AMENDMENT NO. A00005

**Solicitation VA261-17-R-0770
Project 654-17-781
Replace Transformer and Switch for MRI Wing**

Photo #1: Existing MRI Transformer – Information Plate

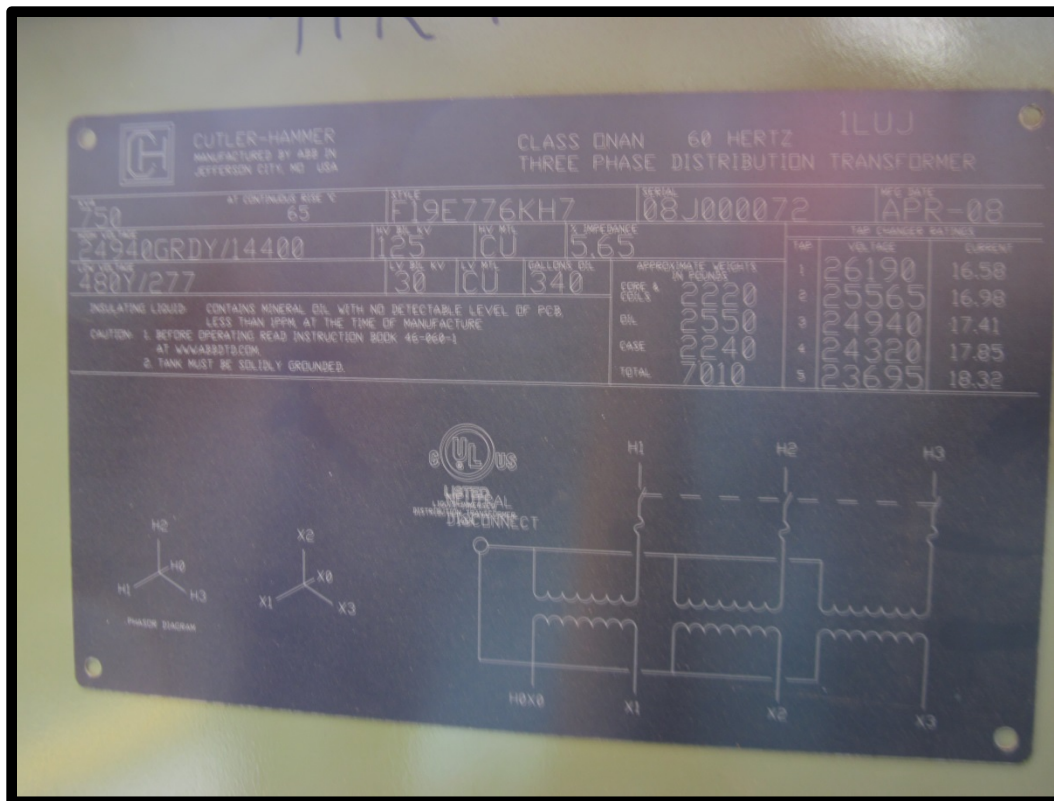
- m. Question: *Additional photos?*
- n. VA Response:
 - Photo #1: Existing MRI Transformer – Information Plate
 - Photo #2: Existing MRI Transformer – Identification Plate
 - Photo #3: Identification Plate of Load Break Switch from T2-LBSW
 - Photo #4: Medium-Voltage Vault Manhole Cover (note: the vault is dry inside)
 - Photo #5: Inside Medium-Voltage Vault (Looking east)
 - Photo #6: Inside Medium-Voltage Vault (Looking west)
